ORAU agrees with the general approach described in the Work Plan to determine whether current sites conditions are compliant with the remedial action objective (RAO) in the Parcel G Record of Decision (ROD) (Navy 2009). A summary of general comments is provided below. Specific technical comments for consideration are provided in the attached table.

INDEPENDENT REVIEW OF THE
DRAFT PARCEL G REMOVAL SITE EVALUATION WORK PLAN
FORMER HUNTERS POINT NAVAL SHIPYARD
SAN FRANCISCO, CALIFORNIA

Attachment 1

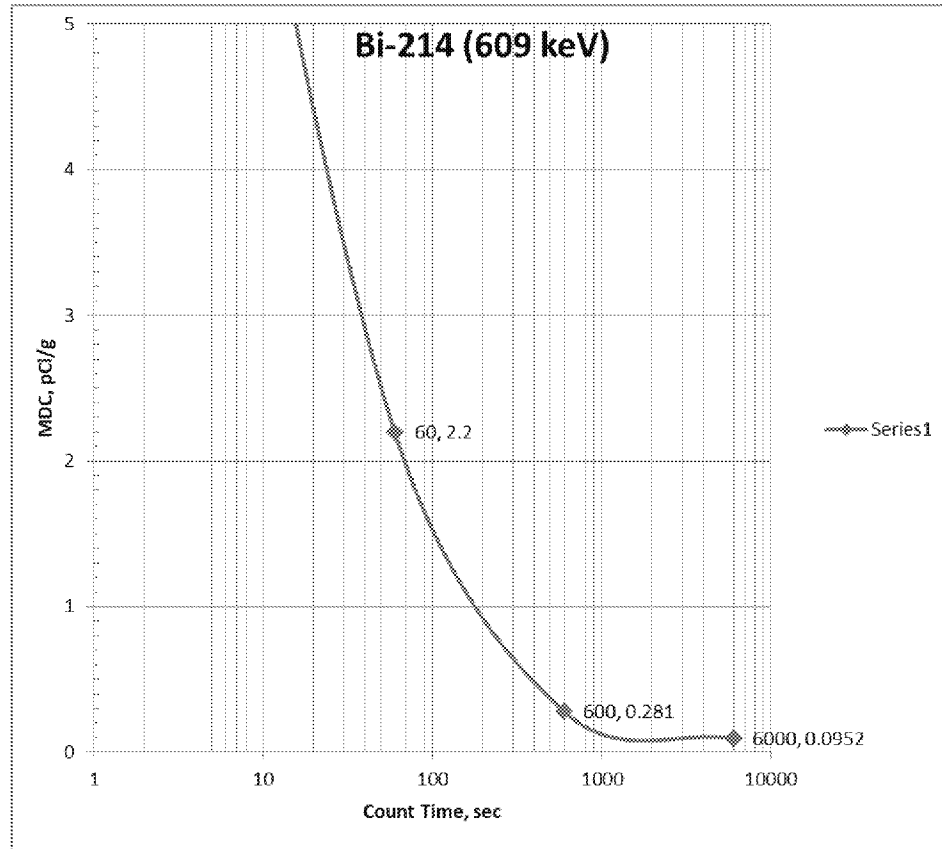
Count Time, sec	MDC, pCi/g
1	14.3
6	7.61
60	2.2
600	0.281
6000	0.0952
